# TECHNICAL SERVICE BULLETIN

## Rear Bumper Cover To Quarter Panel Poor Fitment And/Or Excessive Body Gap - Built On Or Before 04-Dec-2023

23-2434

Ford 2024 Mustang	Built on or before 04-Dec-2023
----------------------	--------------------------------

Figure 2 (Left Side Shown, Right Side Similar)

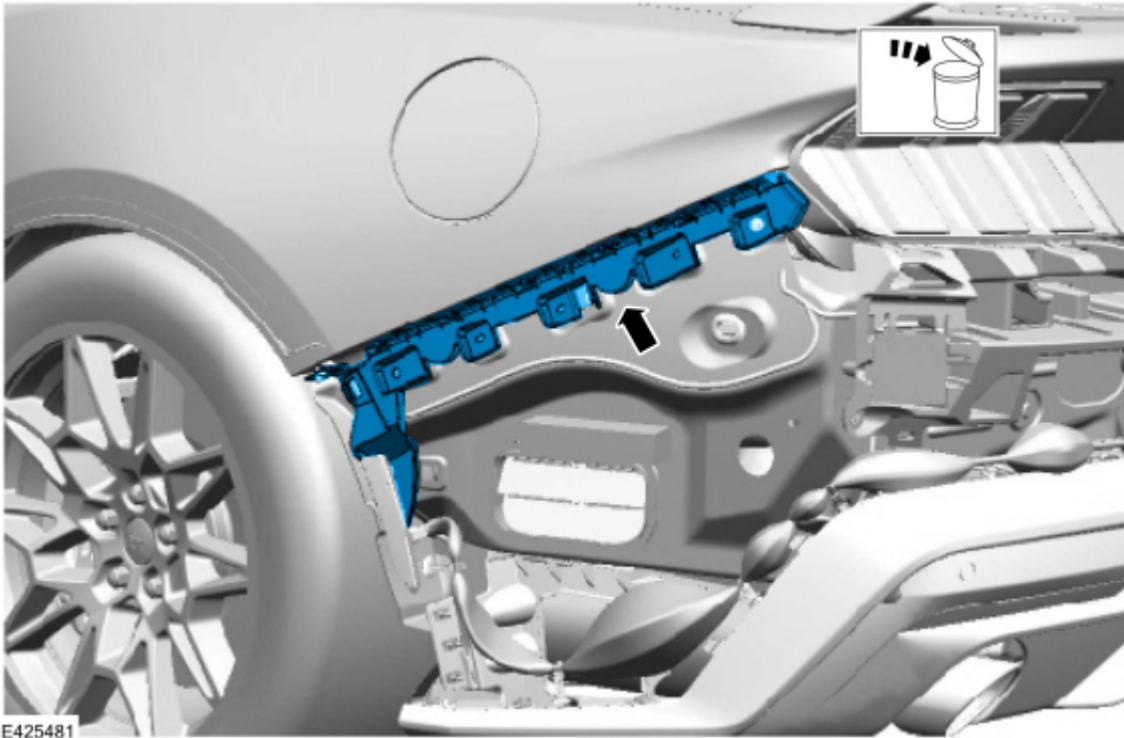
3. Replace the right hand side and left hand side rear bumper cover side brackets shown in Figure 2.

Figure 3 (Left Side Shown, Right Side Similar)

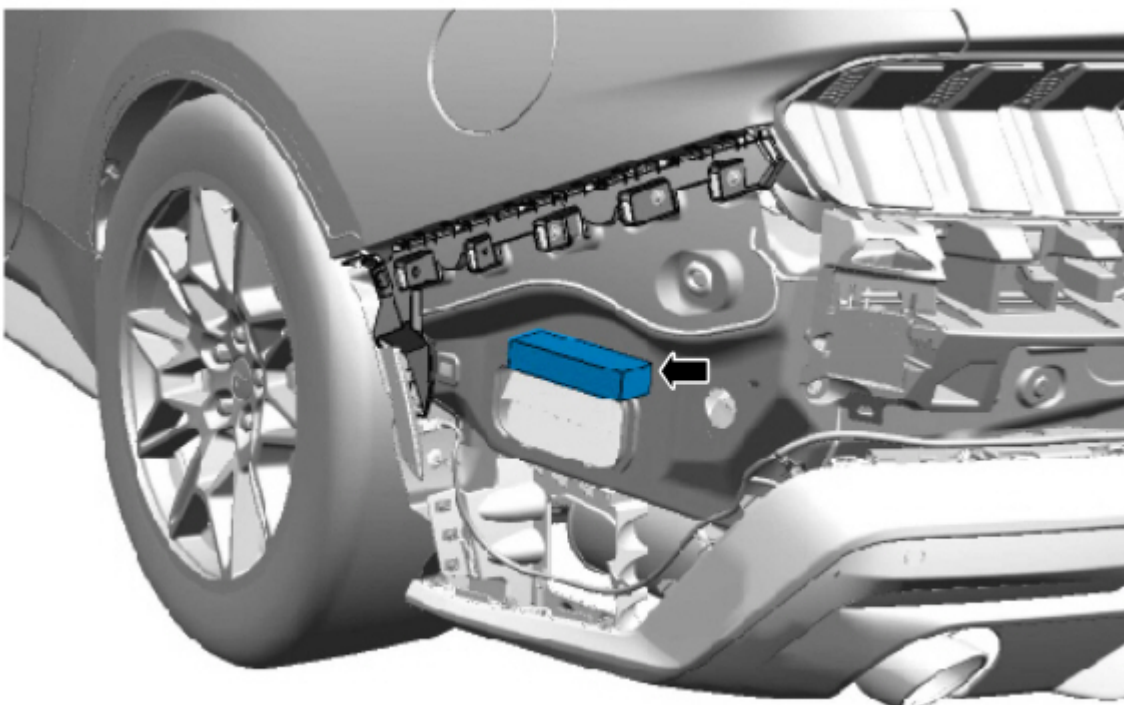
**NOTE:** Be sure that the foam block is located in the area shown in Figure 3 on the left and right side of the vehicle when the rear bumper cover is installed. If the foam block is loose or is missing install a new foam block.
